DART SERVICE INSTRUCTION

TO AMEND INSTALLATION INSTRUCTIONS D350-591 REV. G
AND INSTRUCTIONS FOR CONTINUED AIRWORTHINESS ICA-D350-591 REV. 3

REF TCCA STC: SH92-6
REF FAA STC: SH967NE

A	NEW ISSUE.	JPH	10.06.08
REV.	DESCRIPTION	BY	DATE
DESIGN		DART AEROSPACE LTD HAWKESBURY, ONTARIO, CANADA	
DRAWN		DRAWING NO. REV. A	
CHECKED		DSI 9525 SHEET 1 OF 4	
MFG. APPR.	N/A	TITLE SCALE	
APPROVED		STEP CUSHION CHANGE NTS	
DE APPR.		DATE 10.06.08	
COPYRIGHT © 2010 BY DART AEROSPACE LTD THIS DOCUMENT IS PRIVATE AND CONFIDENTIAL AND IS SUPPLIED ON THE EXPRESS CONDITION THAT IT IS NOT TO BE USED FOR ANY PURPOSE OR COPIED OR COMMUNICATED TO ANY OTHER PERSON WITHOUT WRITTEN PERMISSION FROM DART AEROSPACE LTD.

FIGURE 32-9: Crosstube Attachment
REF ICA-D350-591

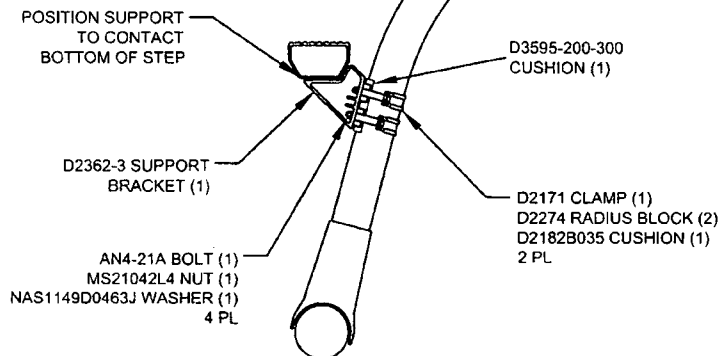
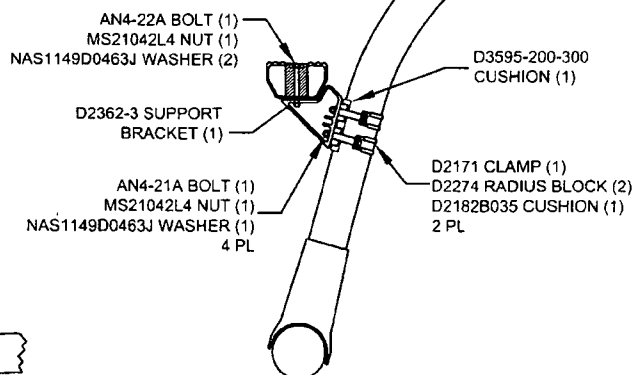
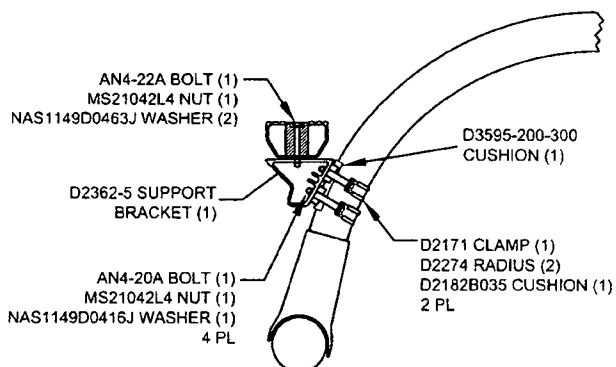
TO PROVIDE AN OPTIONAL CUSHION KIT TO BE INSTALLED ON THE D350-591-111A/-113/-115/-117A/-119 Heli-Access-Step™ (THE D2856-400-720 ABRASION STRIP IS REPLACED WITH THE D3595-200-300 CUSHION).

1. REMOVE THE STEP PER ICA-D350-591 SECTION 32.2
2. REMOVE THE D2856-400-720 ABRASION STRIP PER ICA-D350-591 SECTION 32.4
3. POSITION THE D3595-200-300 CUSHION AS INDICATED ON SHEET 3 OR 4 (AS APPLICABLE) OF THIS SERVICE INSTRUCTION.
4. REINSTALL THE STEP PER ICA-D350-591 SECTION 32.1 AS APPLICABLE USING THE NEW HARDWARE PROVIDED AS SHOWN ON SHEET 3 OR 4 (AS APPLICABLE) OF THIS SERVICE INSTRUCTION.
